SUBJECT: BRUNSWICK STEAM ELECTRIC PLANT, UNITS 1 AND 2; SHEARON HARRIS NUCLEAR POWER PLANT, UNIT 1; H. B. ROBINSON STEAM ELECTRIC PLANT UNIT NO. 2; AND OCONEE NUCLEAR STATION, UNITS 1, 2, AND 3 – ISSUANCE OF AMENDMENTS TO CONSOLIDATE EMERGENCY OPERATIONS FACILITIES AND ASSOCIATED EMERGENCY PLAN CHANGES (CAC NOS. MF7650, MF7651, MF7652, MF7653, MF7654, MF7655, MF7656, MF7657, MF7658, MF7659, AND MF7660)

SAFETY EVALUATION BY THE OFFICE OF NUCLEAR REACTOR REGULATION

AMENDMENT NOS. 279 AND 307 TO RENEWED FACILITY OPERATING LICENSE

### 3.2.2 Emergency Response Organization Augmentation Time

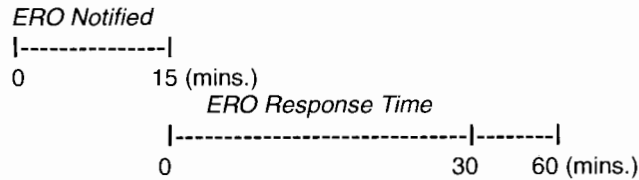
Duke Energy has requested that the ERO augmentation times for the Brunswick, Harris, and Robinson sites be changed so that they are consistent with the times for the Catawba, McGuire, Oconee, and Lee sites, which are currently served by the Duke Charlotte EOF.

[Duke] Charlotte EOF members are currently required to augment within 75 minutes from [the time of] declaration of an Alert or higher event classification. The BSEP [Brunswick], HNP [Harris], and RNP [Robinson] required EOF augmentation times are 60 to 75 minutes from [the time of] notification of an Alert or higher event classification. Thus, to support the EOF consolidation, Duke Energy also requests to change the augmentation time of the 60 to 75 minute (from notification) responders at BSEP, HNP, and RNP to 75 minutes (from declaration). Similar to this request, all HNP and RNP 30 to 45 minute (from notification) responders are requested to be changed to 45 minutes (from declaration). BSEP does not have 30 to 45 minute responders.

Duke Energy is requesting that if an ERO responder currently responds within 30 to 45 minutes from notification, those responders should now be allowed to respond within 45 minutes from event declaration. Additionally, if a responder currently responds within 60 to 75 minutes from notification, those responders would now be allowed to respond within 75 minutes of event declaration. This change effectively results in ERO augmentation being required within 45 and 75 minutes of classification, respectively. This change is acceptable, since the existing emergency plans for Brunswick, Harris, and Robinson currently allow up to 15 minutes from the time of event declaration to notify ERO responders. As such, the proposed change does not impact the overall timeframe for ERO response within 45 and 75 minutes, respectively, from the time of event declaration (see below).

Based on the foregoing considerations, the NRC staff concludes that Duke Energy's proposed changes to augmentation of response capabilities continue to meet (1) the requirement of 10 CFR 50.47(b)(2), which specifies, in part, that timely augmentation of response capabilities is available; (2) the requirements in Appendix E.IV.C to 10 CFR Part 50, which describe, in part, the need for alert and activation of the emergency organization at specified emergency action levels; and (3) the evaluation criteria of Section II.B of NUREG-0654.
